CD Autochanger – Transit Screws –  
Storage Location

MODEL 1995-96 MY  
Sedan Range  
VIN  
720001-ON

ILLUSTRATION 1

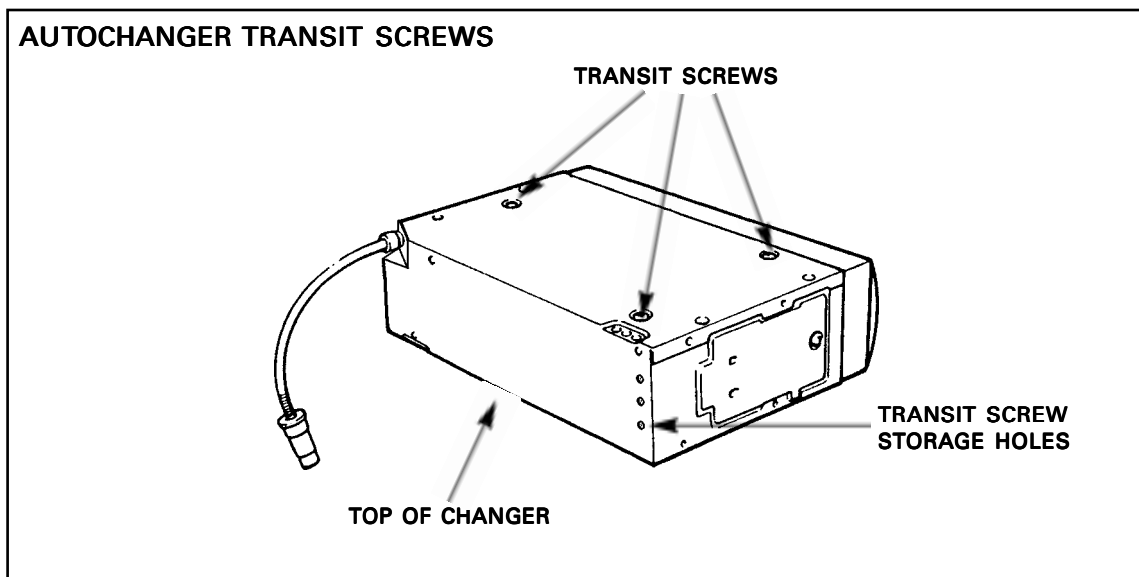
Starting with VIN 787300, these screws should be placed in the storage holes now provided on the rear face of the unit.

The storage location is shown in Illustration 1.

When removing the CD Autochanger for repair or replacement, **reinstall all three** transit screws into the three holes on the bottom of the unit, before the Autochanger is packed for shipping.

**NOTE:** Correct installation of **all three** transit screws is essential to prevent damage to the mechanism during shipping.
